PRODUCT CHANGE NOTIFICATION

Date: November 6, 2024
PCN: PCN LEDIL 200

Subject: PCN 200 – Change of AMY holders used with asymmetric beam versions

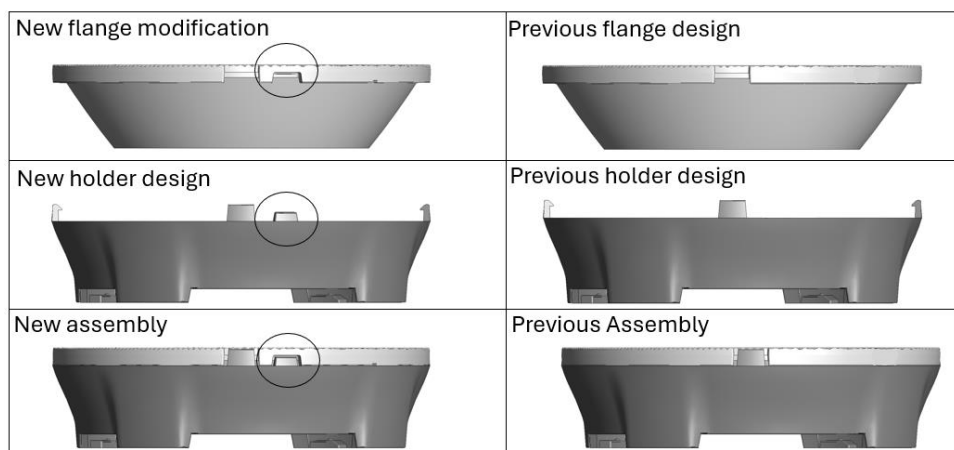
Description: As part of our continuous improvement process, LEDiL is releasing new holders for the asymmetric AMY lenses and assemblies and making a minor modification to the flange design of the lenses. The new holder versions come with a small counter shape to match a new slot in the AMY lens design, to ensure correct orientation of the asymmetric lens versions and prevent assembly errors.

Symmetrical beams versions of the AMY lenses will also feature a slot in the flange but will continue to use the existing holders.
